Re: Lot 758, Sunrise Beach  
Crownsville, MD 21032  
Tax #2748-0425-9250

On behalf of our client, Sikora Properties, LLC, owner & developer of the above-referenced property, we are submitting herein a variance request to Article 17-8-201(a) of the Anne Arundel County Code.

**VARIANCE & GRADING & SEDIMENT CONTROL PLAN**  
**LOT 758, SUNRISE BEACH**  
PLAT BOOK 23, PAGE 18  
TAX MAP 31 BLOCK 8, PARCEL 142  
ZONED R2

## OFFICE OF PLANNING AND ZONING

**VARIANCE & GRADING & SEDIMENT CONTROL PLAN**

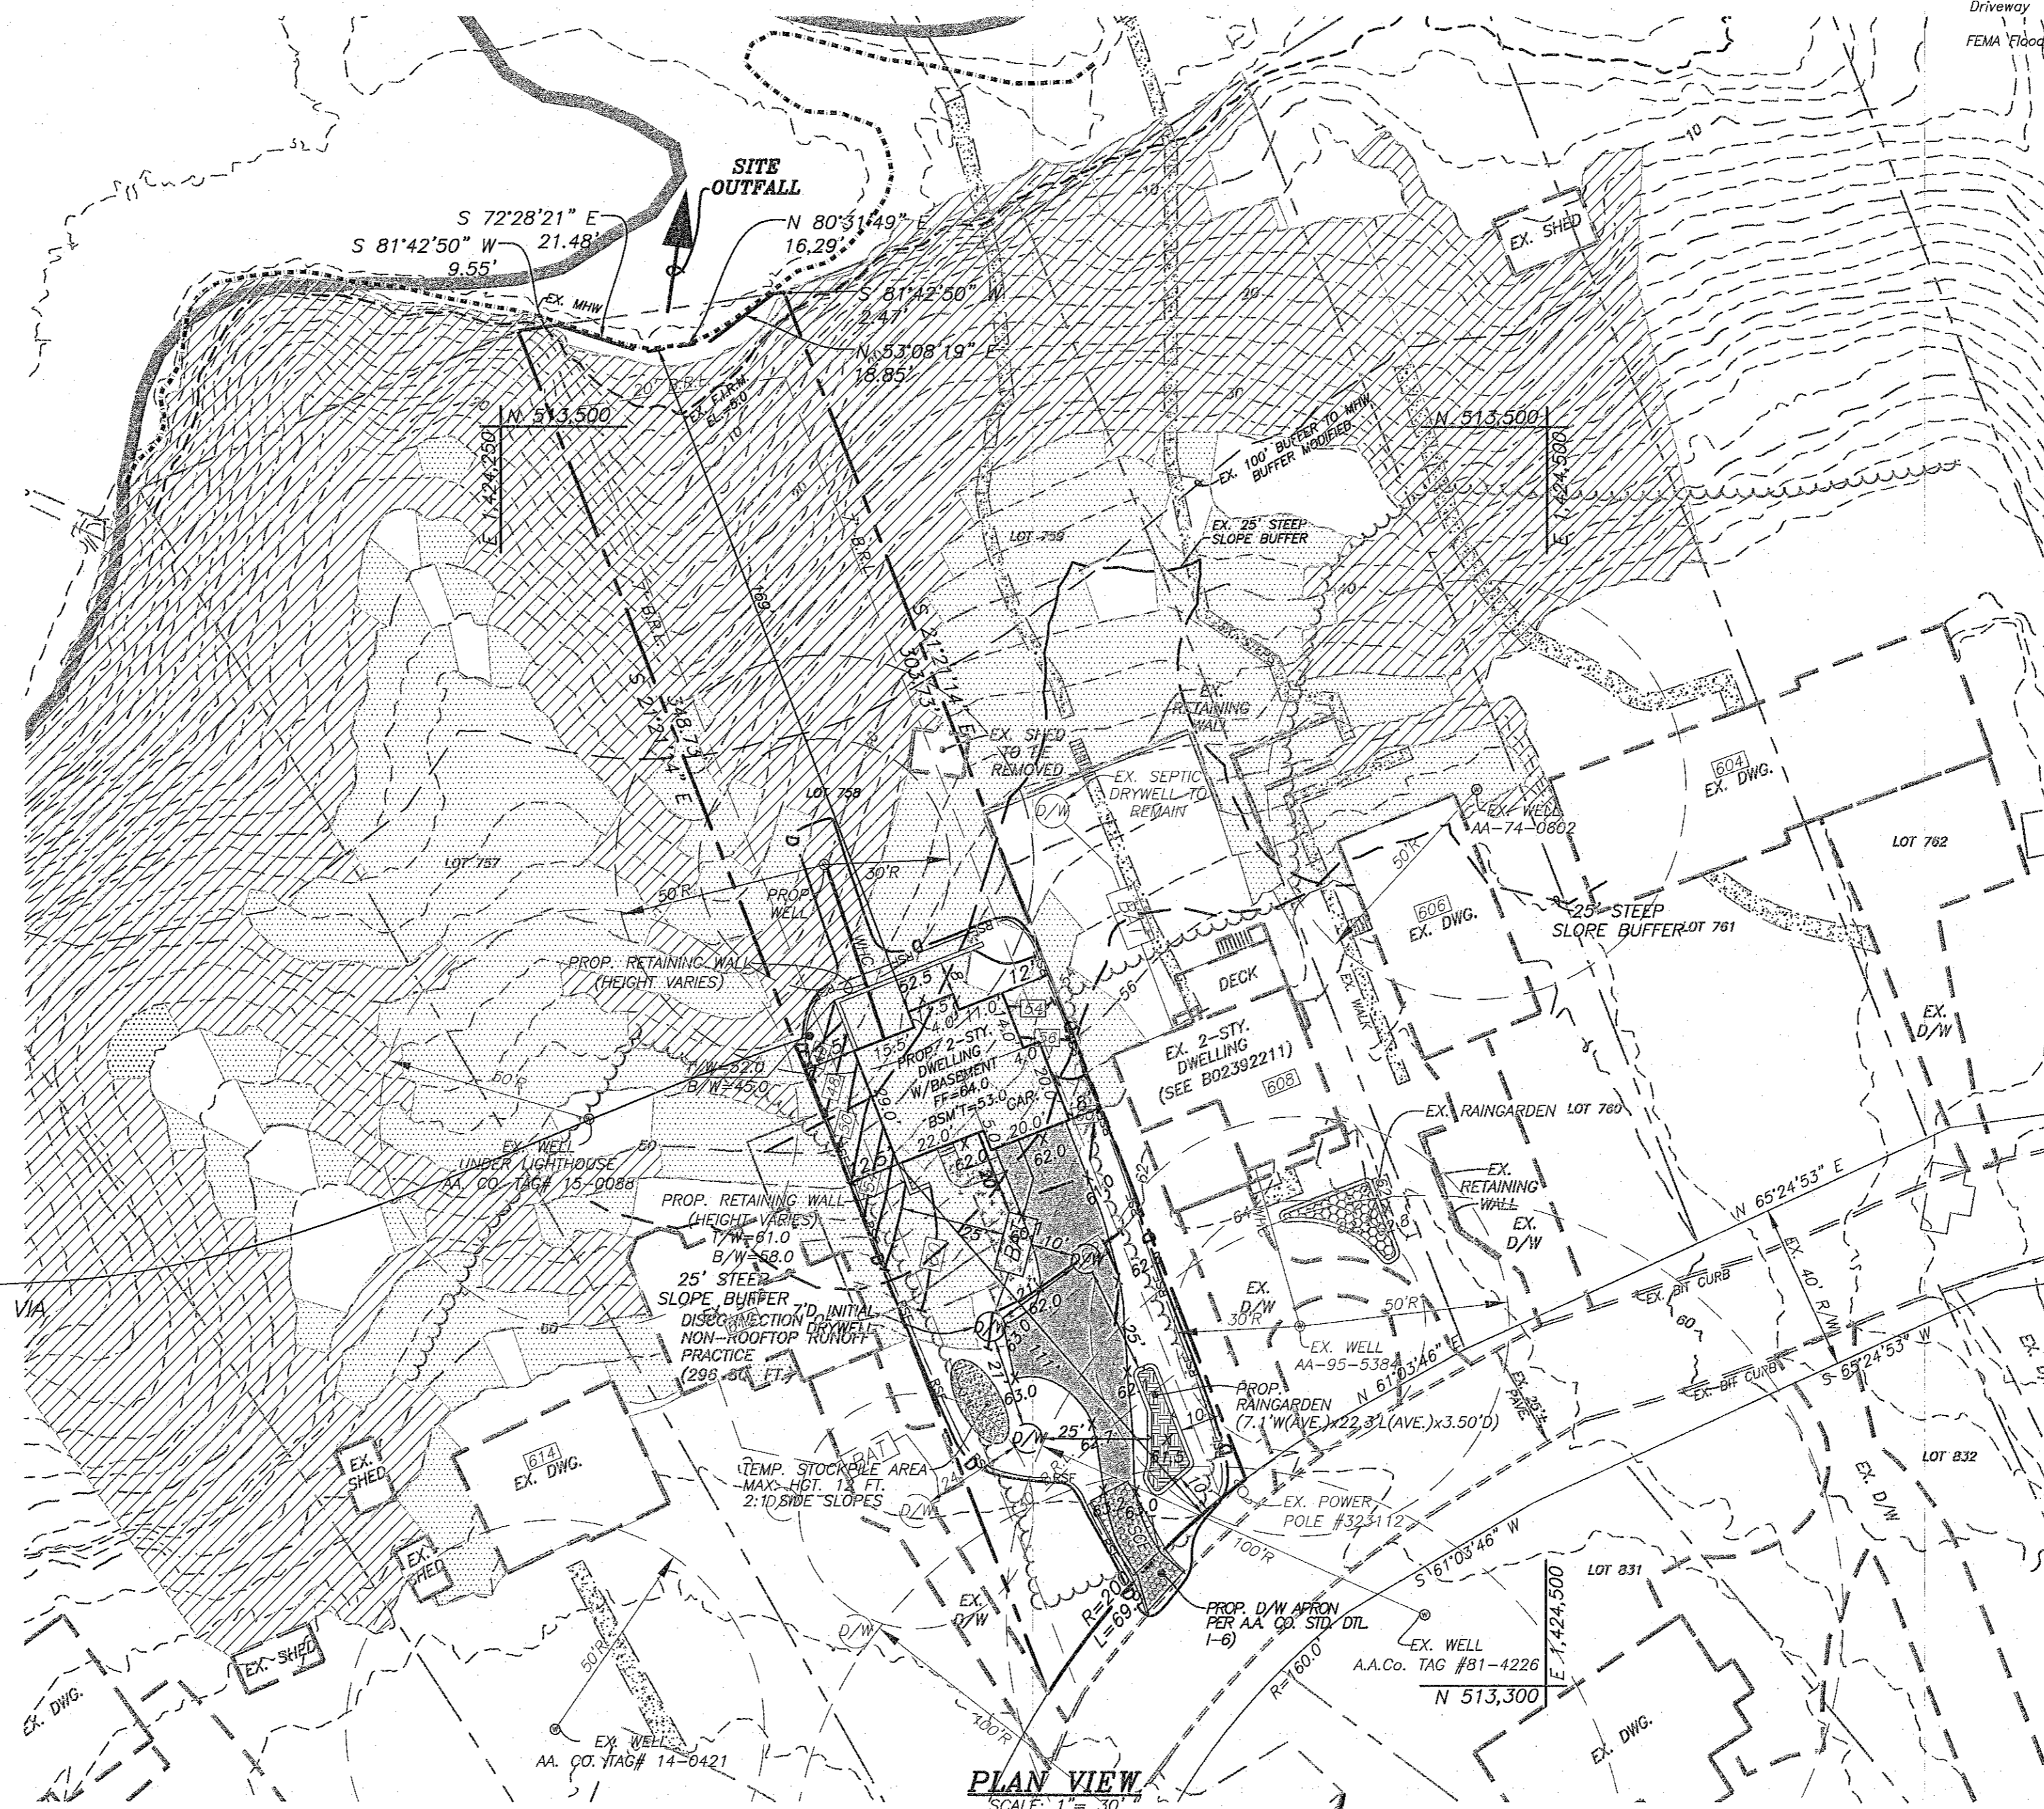
**Consideration of alternative surfaces:** The provided information rules out the use of green roofs. Cost should not be a justification for ruling out ESD to the MEP design in the critical area when considering issuing a modification for the construction of a new single-family dwelling with steep slope disturbances.

**Setback requirements:** The submitted plan must show clearly with dimensions the setback provided from the proposed Stormwater facilities to the proposed house, the adjacent property lines, the top of the 15% steep slope, the proposed well, etc.

This office does not recommend approval of this variance request. First, the requested information regarding the condition assessment for the steep slope and outfall was not provided. In addition, the engineer did not show the required right to discharge from the adjacent property owner (612 Echo Drive). Further, the designer has not demonstrated that ESD to the MEP is met. The roof drains were not shown on the plan, and no SWM treatment was provided for them. Given the steep slopes and the proposed site layout, this office feels that the development of this site, as shown, will have detrimental impacts on the neighboring properties and slope stability. It also does not meet the regulatory minimum SWM ESD to the MEP.

**SEPTIC & VARIANCE SITE PLAN**  
**LOT 758, SUNRISE BEACH, SECTION 5**  
Plot Sheet 23, Page 75  
TAX MAP 51 BLOCK 8 PARCEL 142  
ZONED R2

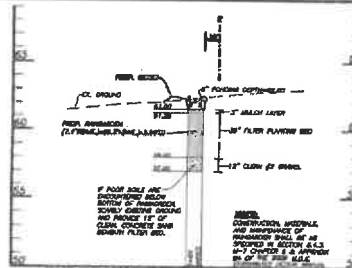
**Critical Area team** advised the well information shown on this plan is significantly different than the information shown on the grading permit for the development of the adjacent site, 608 Echo Cove Dr. An approved septic and well design must be submitted before this site can be fully evaluated. In addition, the applicant must demonstrate that SWM can be addressed. The proposal will also need a relatively in line variance.

**ESD design:** The existing condition plan must show all existing natural and environmental resources and include all areas to be protected. The plan must clearly show the "developable envelope outside of these areas. These areas include steep slopes, wetlands, streams, buffers, floodplains, highly erodible soils, specimen trees, soils (A, B, C, and D), hydric soils, etc.

**Consideration of alternative surfaces:** The provided information ruling out the use of green roofs and permeable pavement for the driveway is not sufficient. Cost should not be a justification for ruling out ESD to the MEP design in the critical area when considering issuing a modification for the construction of a new single family dwelling.

**Soil investigation:** No information was provided on the elevation of the water table and the ability to maintain adequate clearance for the proposed rain gardens. It is also not specified whether under drains will be needed or not and their discharge point. The soil edibility index must be added to the plan. Highly and potentially highly erodible soils must be considered for enhanced stabilization during construction.

**Setback requirements:** The submitted plan must show clearly with dimensions the setback provided from the proposed Stormwater facilities to the proposed house, the adjacent property lines, the top of the 15% steep slope, the proposed well, etc.
